Sheppee International Press Release

SM Module Upgrade

August 2013

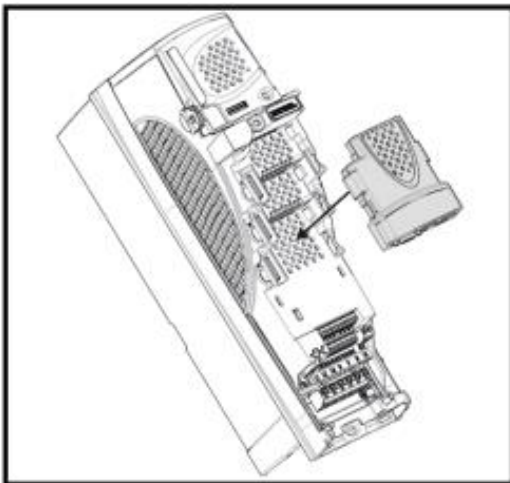
Due to advancement in the capability of the processing power of the IPC's used on the Triflex Lehr loader, the IPC's now being installed in the machine are able to process data at a much faster rate than the IPC's previously installed.

As the transfer of data is quicker, Sheppee have identified a requirement to upgrade the SM Modules used on all the servo drives to future proof the machines. From the 19th August 2013 all Modules supplied by Sheppee International Limited for use on the Triflex Lehr Loader machine will be the SM Applications Plus Type.

This includes when requested as replacements for existing machines. There is no upgrade requirement, the two modules can just be swapped, and it is not necessary to change all modules at once as the old and new will work alongside each other.
